Access Compliance Report

Public Rights-of-Way

(Curb Ramps)

Intersection ID: 45795	Main Street: SHELLVIEW_LN	Cross Street: WINDING_RIVER_DR	Location: NE
ADA ID: 8365DCBA2DAC	Ramp Type: BlendTrans1	Initial Pass/Fail: Fail	Overall Compliance: No
Severity Score: 33.75			
Codes/Mitigation Info/Possible Solution		Field Measurements/Component Compliance

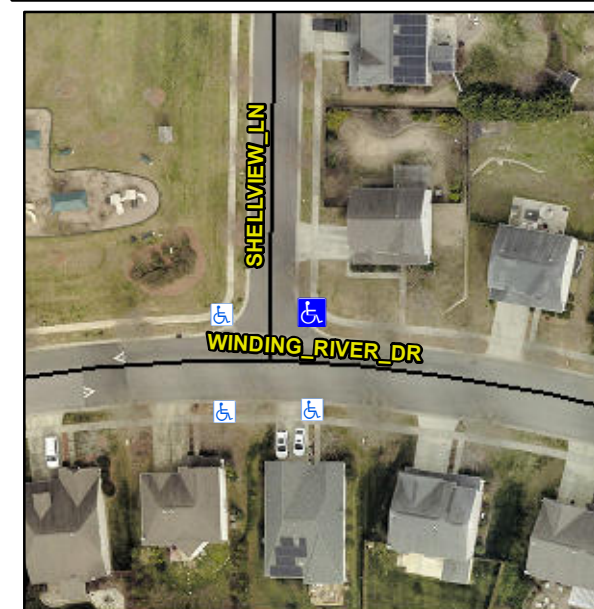
R304.5.1, R304.5.3

Compliance	Description	Data	Compliance	Description	Data
N/A	Ramp Length (in)	73.0	Yes	BlendTrans Slope (%)	4.2
No	Ramp Width (in)	47.5	No	BlendTrans XSlope (%)	9.0
N/A	Flare Type LT	N/A	N/A	Flare Type RT	N/A
N/A	Flare Slope LT (%)	N/A	N/A	Flare Slope RT (%)	N/A
N/A	Flare Traversable LT?	N/A	N/A	Flare Traversable RT?	N/A
N/A	Landing Length (in)	N/A	N/A	DWS Provided?	N/A
N/A	Landing Width (in)	N/A	N/A	DWS Contrast?	N/A
N/A	Landing Slope (%)	N/A	N/A	DWS Length (in)	N/A
N/A	Landing X Slope (%)	N/A	N/A	DWS Full Width?	N/A
N/A	Landing Curb? (Y/N)	N/A	N/A	DWS Offset (in)	N/A
N/A	Shared Landing?	N/A			
N/A	Gutter Ponding?	N/A	N/A	Gutter Slope (%)	N/A
N/A	Gutter Lip Ht (in)	N/A	N/A	Gutter X Slope (%)	N/A
N/A	Painted X Walk1?	No	N/A	Painted X Walk2?	No
	X Walk 1 Direction	To W		X Walk 2 Direction	To S
	X Walk 1 Width (in)	N/A		X Walk 2 Width (in)	N/A
	X Walk 1 Slope (%)	2.7		X Walk 2 Slope (%)	1.9
	X Walk 1 X Slope (%)	7.9		X Walk 2 X Slope (%)	4.8

N/A	Ramp inside XWalk1?	N/A	N/A	Ramp inside XWalk2?	N/A
	Road Slope (%)	8.0		Clear Space?	N/A
	Road X Slope (%)	0.7	N/A	Clear Space to XWalk (in)	N/A
N/A	Any Obstructions?	N/A	N/A	Storm Grate/Utility Hazard?	N/A
	Obstruction Type			Storm Grate/Utility Type	
		N/A			N/A
			Yes	Surface Condition? (G/P)	Good
			N/A	Curb Slope (%)	2.1

Remove & Replace Curb Ramp With Two New Directional Ramps or Equivalent.
